LINCOLN CITY/LANCASTER COUNTY PLANNING STAFF REPORT

P.A.S.: PP #01019
Edenton North 6th Addition

DATE: February 6, 2002

PROPOSAL: To create 184 single and two family lots.

Preliminary Plan
on North-Phase II
SITE PLAN

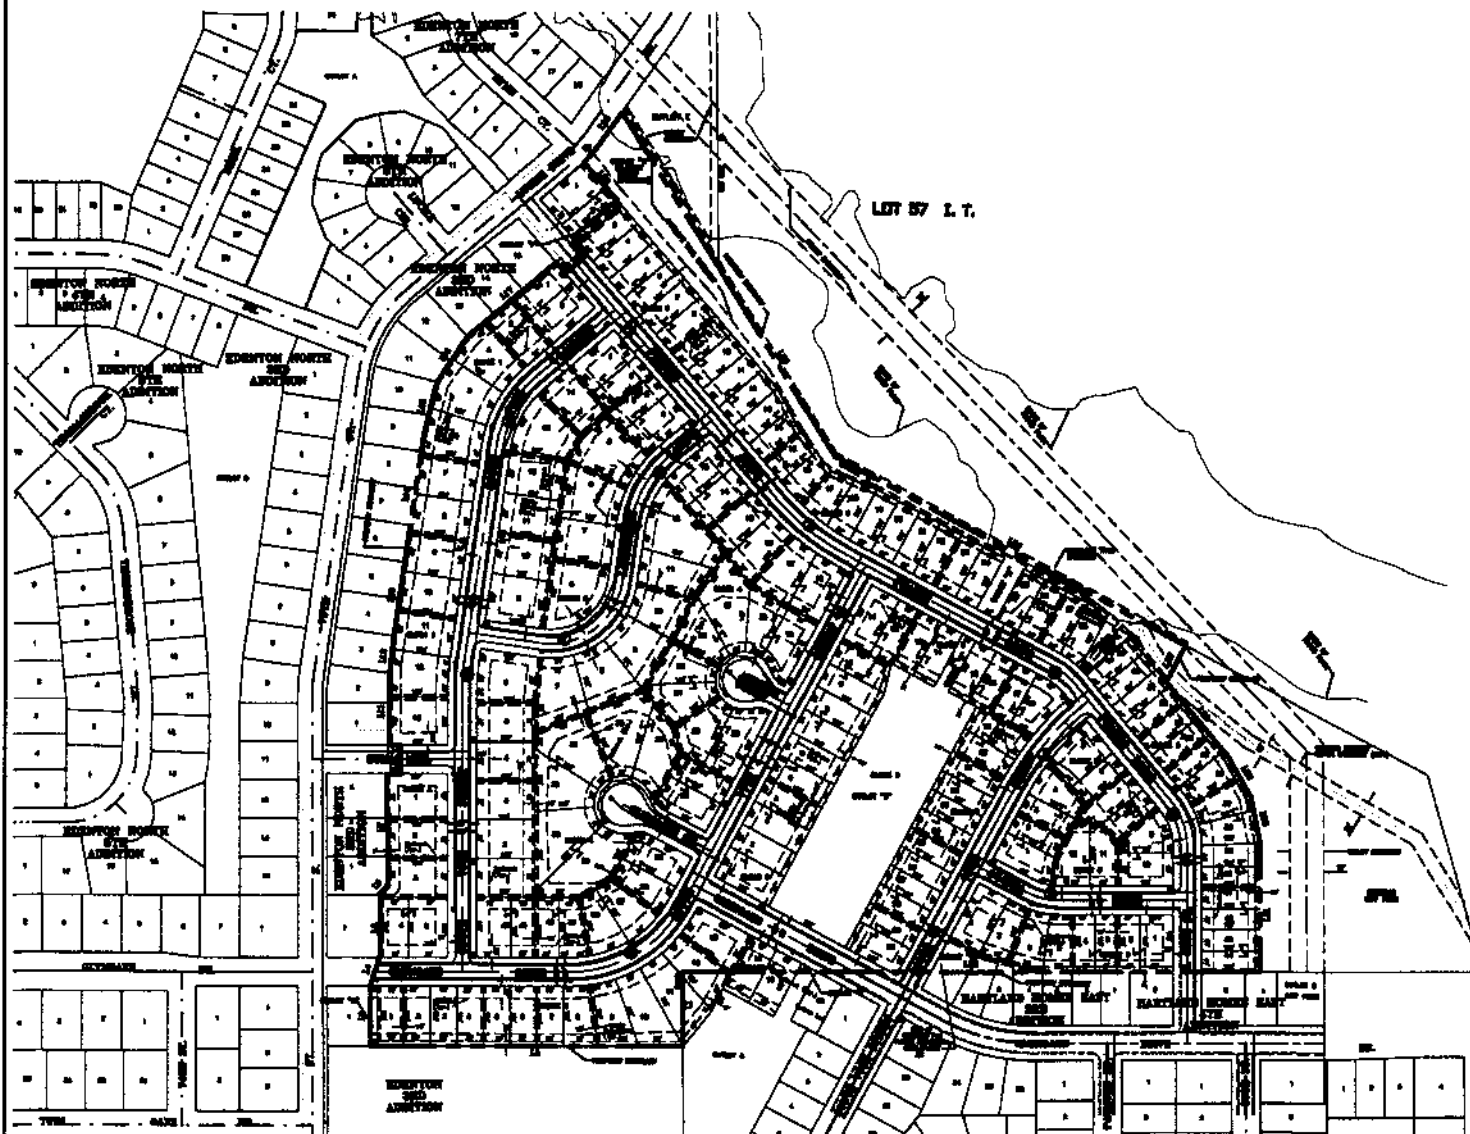
1. The water main in Glynoaks Drive must be 12" in size.
2. The grading and drainage will require a number of revisions, all outlined in the January 17, 2002 memo from Dennis Bartels.

1.1.4 Remove setback lines. They are not required and obfuscate the utility easements.

1.1.6 Provide a pedestrian way easement in Block 4.

1.1.7 Change all references from "Edenton North - Phase II" to "Edenton North 6th Addition" in accordance with plat naming standards.

1.1.8 Relocate the "South" label in "South 77th Street" so that it is north of Glynoaks Drive. This will aid in assigning addresses.

1.1.9 Revise Note 22 so that the easement location will be determined at the time of the final plat.

1.1.10 Remove the lots and use tables. The data required with a preliminary plat are: number of lots, number of outlots, number of blocks, and purpose of outlots.

1. Water - The water main in Glynoaks Drive needs to be shown as 12" in size. This has not been changed per the previous review. I note it has been revised west to 77th, but not west to the west limits of the plat.

The storm sewer shown in Outlot D does not work with the grades. The location of the pipe does not meet the outlet ditch shown on the adjacent property. If the 36" pipe is built with the required cover, the flow line will be below existing grades. The realignment I anticipate being required may require realignment of Lots 24 and 25, Block 6 and Outlot D.

4. Sidewalks - There is not a pedestrian easement shown between Lots 24 and 25 in Outlot D as stated in the letter. There is an easement shown between Lots 28 and 29. In reviewing the grading plan, it appears that a pedestrian easement does not work in either location without revisions to the grading plan.
